**BEFORE THE HEARINGS PANEL
FOR THE PROPOSED QUEENSTOWN LAKES DISTRICT PLAN**

IN THE MATTER of re-notified Stage 1
submissions: Gertrude's
Saddlery Limited and
Larchmont
Developments Limited
at Arthurs Point

**STATEMENT OF EVIDENCE OF MICHAEL ANDREW SMITH
ON BEHALF OF QUEENSTOWN LAKES DISTRICT COUNCIL**

TRANSPORT

Figure 4-3: Existing General arrangement of the Atley Road / Arthurs Point Road intersection

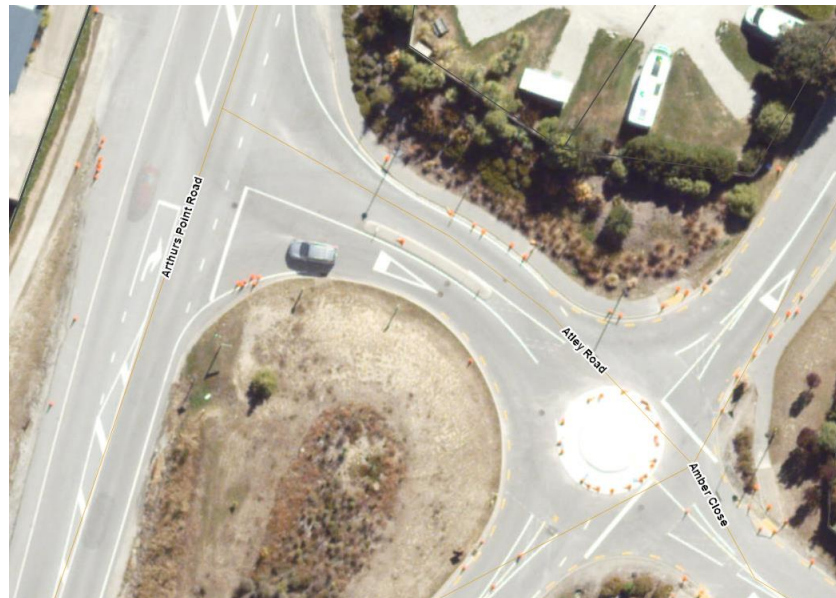
- 4.3** Access to the QLDC road network from the site, is currently via Atley Road, through the Atley Road / Mathias Road / Amber Close roundabout, and forming a Tee-road junction with Arthurs Point Road (refer to Figure 4-3 below).

- 6.9** In reviewing the location of the referenced Bullendale Drive catchment area and intersection form, I note that a key differentiation between the two intersection layouts is that the Atley Road intersection is characterised as having a second intersection control (roundabout) located some 35 metres in from the limit line of the Arthurs Point Road intersection, as indicated in Figure 6-3 below.

- 6.11** Considering the roundabout (Atley / Amber Close; Refer to Figure 6-2 above), I remain concerned that queue back may occur from the Arthurs Point intersection. This could have negative effects on the capacity of the roundabout at am and pm peak. I am of the opinion that the analysis of the intersection is critical to the determination of the traffic effects that could potentially arise as a result of the proposed rezoning.

- 6.12** I consider the necessary assessment for the rezoning is to undertake a suitable intersection analysis utilising tools such as a SIDRA© model, inclusive of all current and proposed development areas to ensure that the intersection form and function is fit for purpose.

Figure 7-1: Access Road Location (Source QLDC GIS)

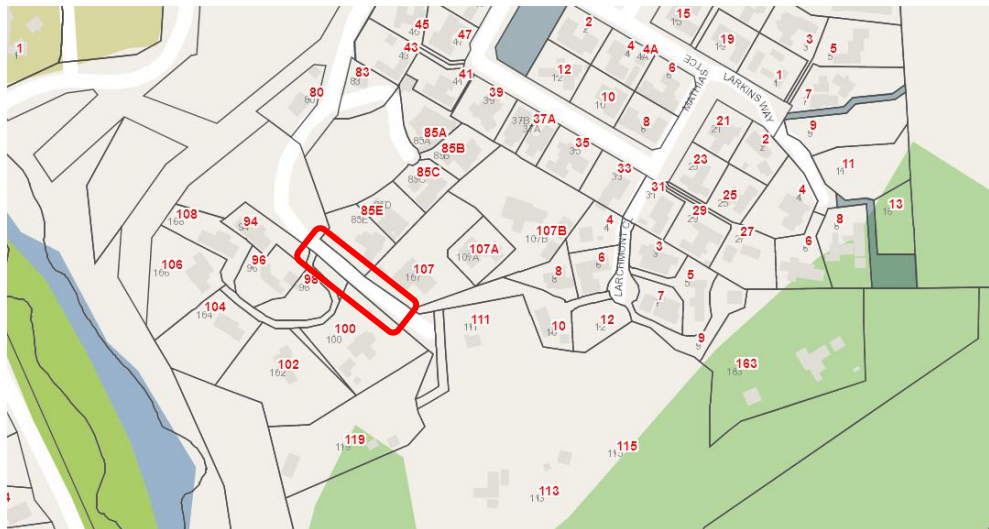
- 7.4 I agree with the Bartlett / Carr evidence that there will be sub-standard widths, albeit that this is not clear when considering current widths, agreements to purchase land to widen, and the final outcome.

7.5 I am aware of the land parcel changes proposed under RM170551 (as detailed below), and the additional width that this creates for the constricted section detailed above. This will result in a corridor width of 9.5 metres.

Figure 7-2: Land Parcel Exchange Area (RM170551)

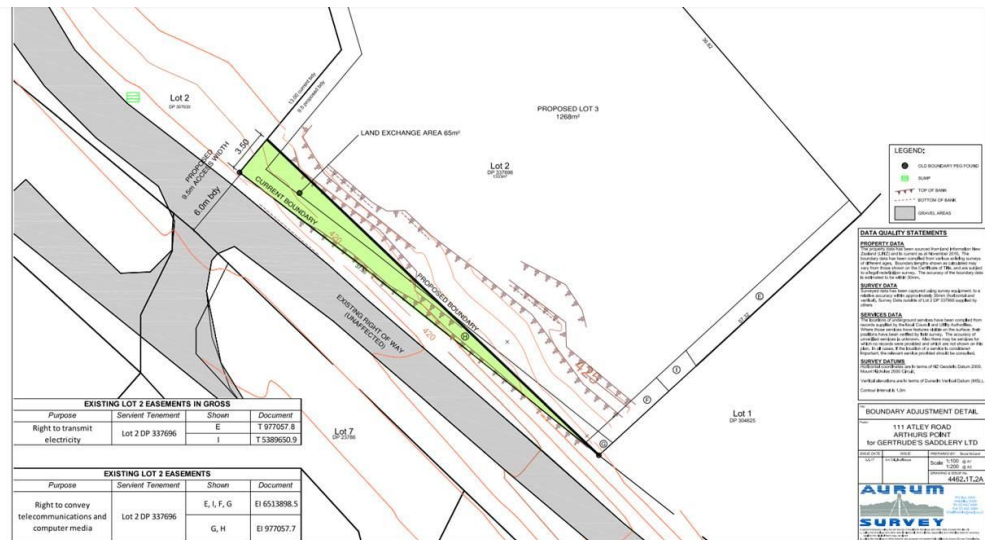
7.6 In reviewing the proposed lot yield for the Land Use Change (30 Lots), I note that the total number of lots that will be serviced by the proposed corridor will remain of the same evaluation criteria, being Suburban: Live and Play, 1 to 200 domestic units.¹⁰ This does not change the original assessment.

Figure 7-4: Upslope – opposite drive to 94 - 106

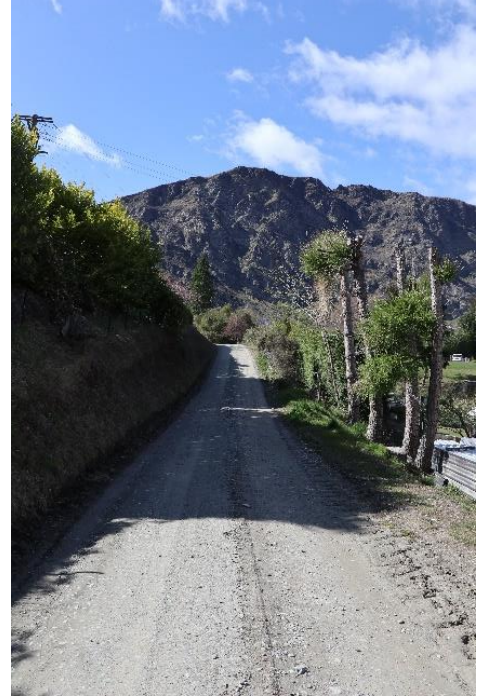
- 7.9** The road width at the gate to #98 Atley Road is 3 metres, with a steep upslope cut (>2.5m) and downslope on the outer edge. If this section was to be widened to accommodate the proposed rezoning, there would be significant earthworks, with potential impacts on the adjacent properties. The downslope fill would be possible but would be of height that would require safety barrier protection, to prevent an errant vehicle penetrating into dwellings below the road level.

- 7.10** Widening of the access road for the development would have negative effects on the driveway access to #94 – 108. The driveway would be required to be steepened and would almost certainly not meet QLDC requirements for change of grade.

- 7.11** From observations on site, I am especially concerned about the narrow road section through the tight curve in the alignment. The location of the curve as detailed in Figure 7-3 and Figure 7-4 above reveals that the upslope height exceeds 10 metres and would require extensive cut to widen the road formation.
